Engineering II-Bldg. 503, Laboratory Remodel, Rooms  
1119B & 1119E  
Project No. FM090301S/987722  
**Addendum No. 1**

ADDENDUM NUMBER 1  
to the  
CONSTRUCTION DOCUMENTS  
May 29, 2009

ENGINEERING II - BLDG 503  
 LAB REMODEL  
 ROOMS 1119B and 1119E  
 UNIVERSITY OF CALIFORNIA SANTA BARBARA

S1

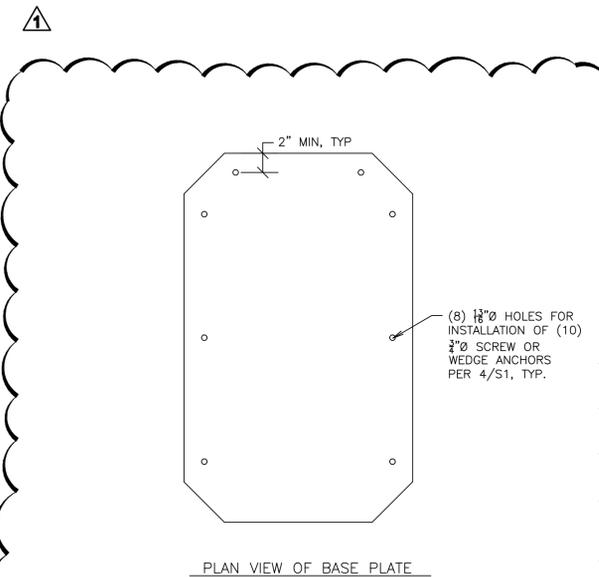
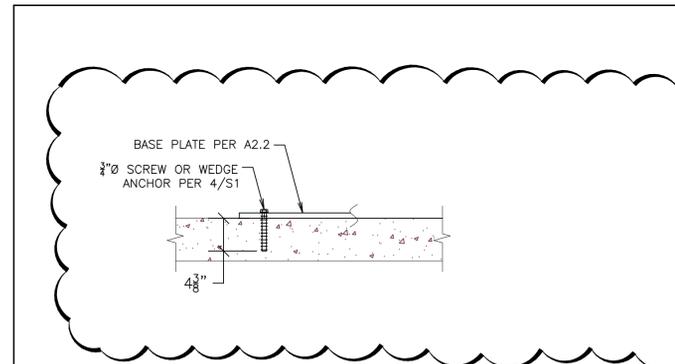
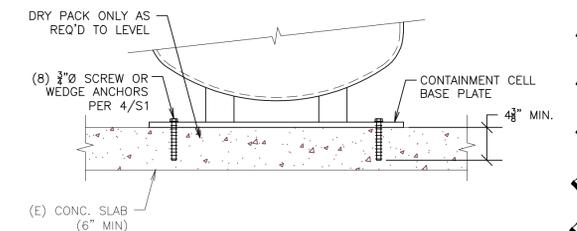
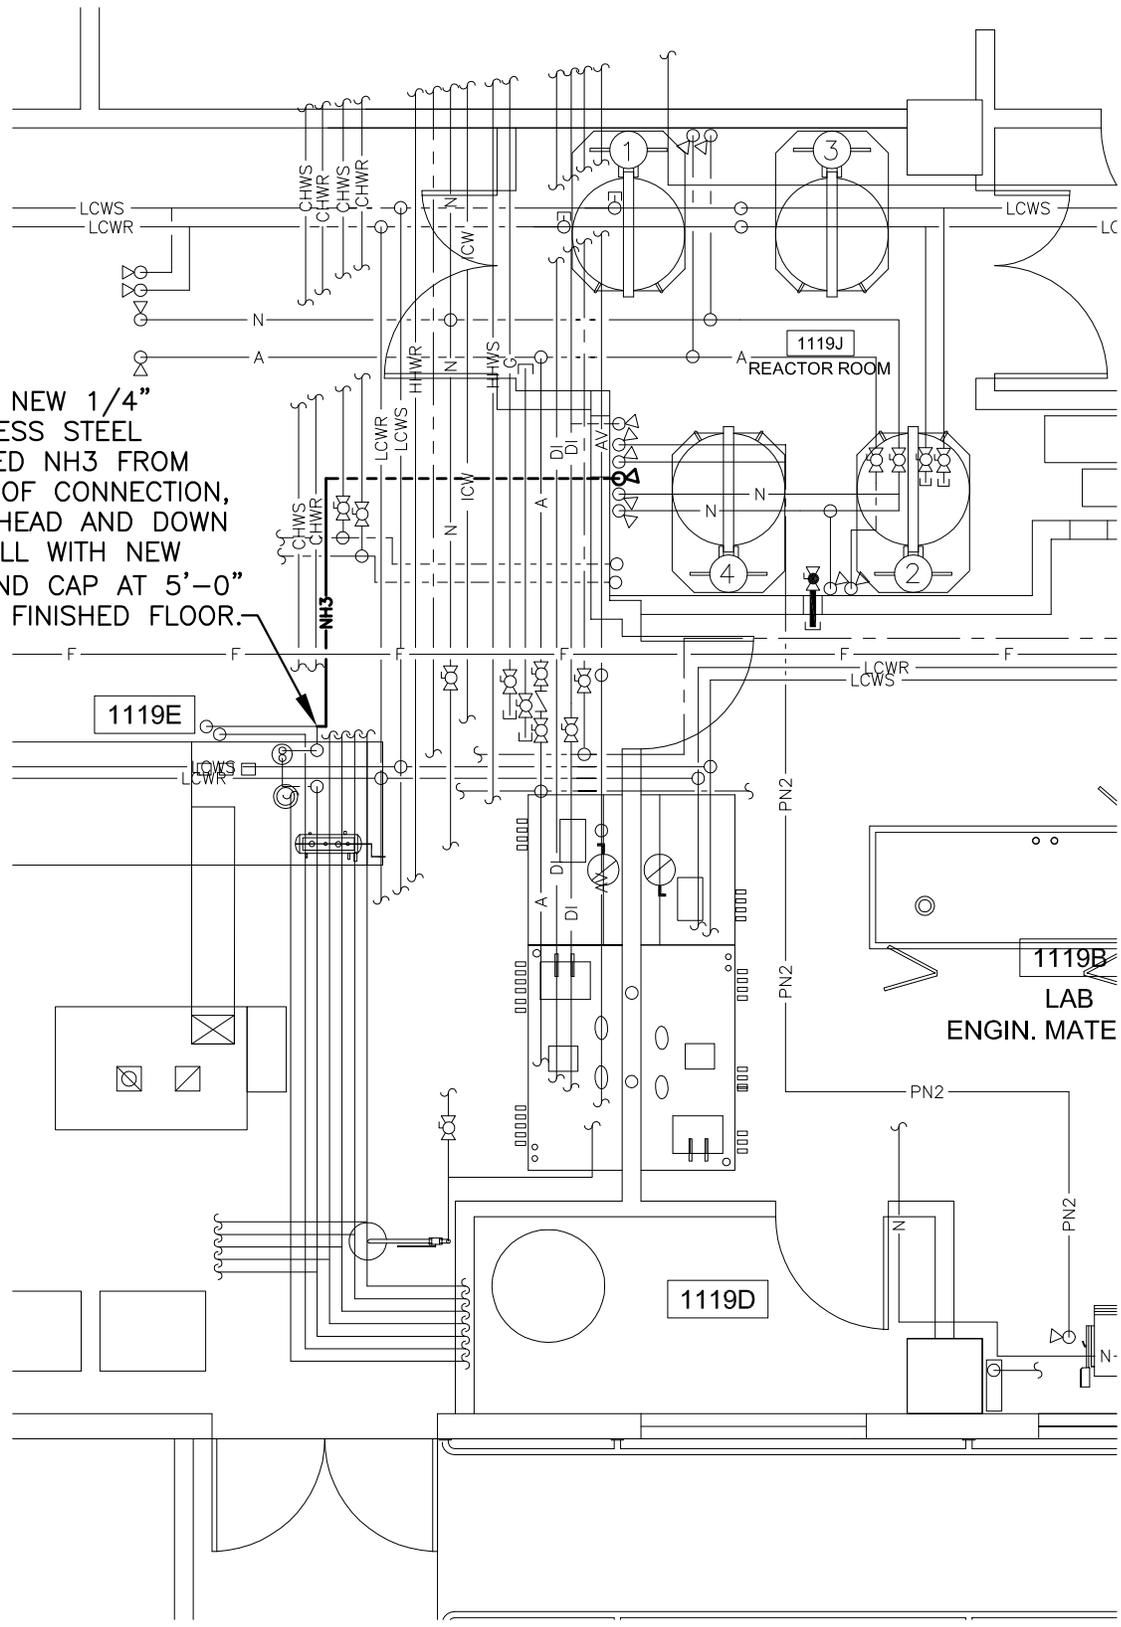
3. Drawing No. S1, STRUCTURAL PLAN, GEN. NOTES & DETAILS. **Replace** in its entirety with attached drawing S1, dated 5/28/09.

**PLUMBING PLAN REVISION**

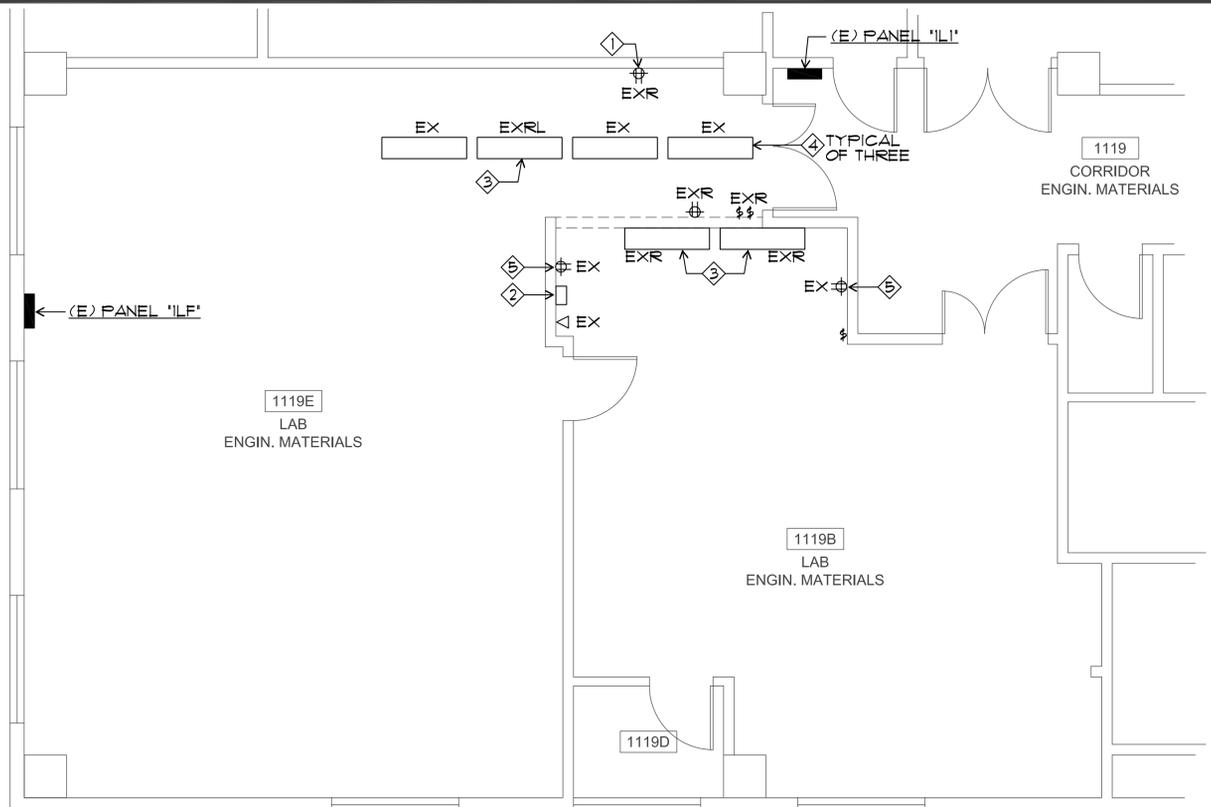
4. Drawing No. P2.0, PLUMBING PLAN. **Revise** the Plumbing Plan with attached drawing ADD 1, dated 5/28/09.

**Revised** as follows: The point of connection for the purified NH3 line in room 1119E has been revised.

1  
 ROUTE NEW 1/4"  
 STAINLESS STEEL  
 PURIFIED NH3 FROM  
 POINT OF CONNECTION,  
 OVER HEAD AND DOWN  
 ON WALL WITH NEW  
 SOV AND CAP AT 5'-0"  
 ABOVE FINISHED FLOOR.

REVISIONS:  
 1 5-28-09  
 UNIVERSITY  
 REQUESTED  
 ROUTING  
 MODIFICATION.
